ADDENDUM NUMBER 2

**Mirmina Residence
22 James Street
Milford, Connecticut**

Project Number 1249

22nd of July 2015

1 PROPOSED BASEMENT PLUMBING PLAN
P1 SCALE: 1/2"=1'-0"

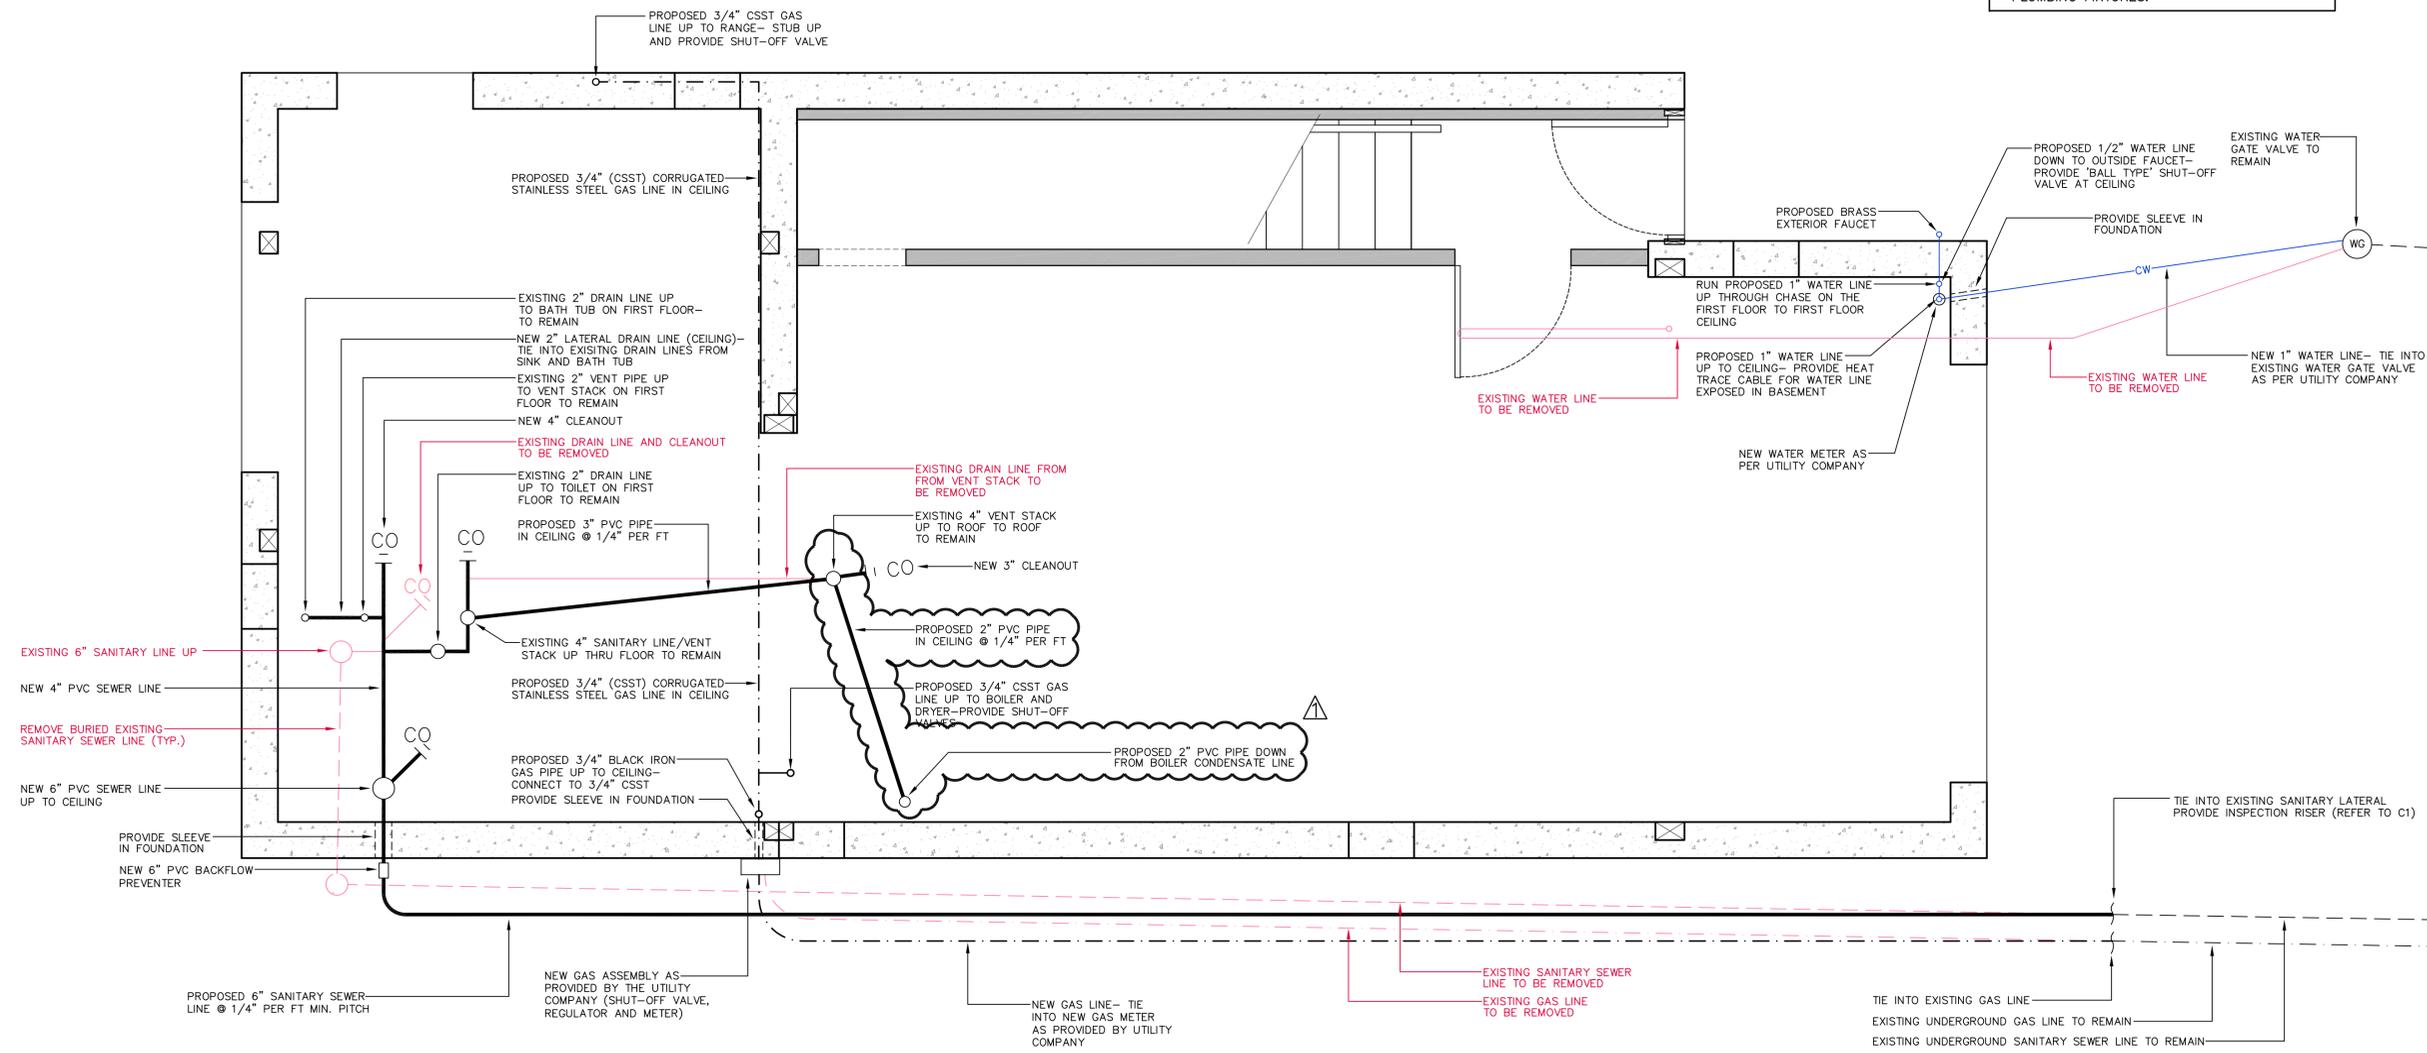
11	Drawing P1	Revised P1 Drawing – Revisions to Drawing include, but may not be limited to the following items; Provide a new condensate line for the condensing boiler, which includes related 2" PVC piping and cleanouts as indicated on the Drawing.
12	Drawing P2	Revised P2 Drawing – Revisions to Drawing include, but may not be limited to the following items; Provide new hot and cold water piping as indicated on Drawing P2, provide new baseboard in locations shown.
13	Drawing A1	Concrete Slab - Delete reference to 5" thick concrete slab with reinforcing from scope of work.
14	Section 23500	Delete Specification Section 23500 – Delete the Specification Section 23500 included in the Bid Set entitled Condensing Boiler.
15	Section 23500	Add Specification Section 23500 – Add the Specification Section 23500 included with this Addendum entitled Condensing Boiler.
16		Change Orders – Modification to Wording – For all change orders up to \$25,000.00, Overhead and Profit can be calculated at 15 Percent. For Change Orders over \$25,000.00, Overhead and Profit should be calculated at 12 Percent.
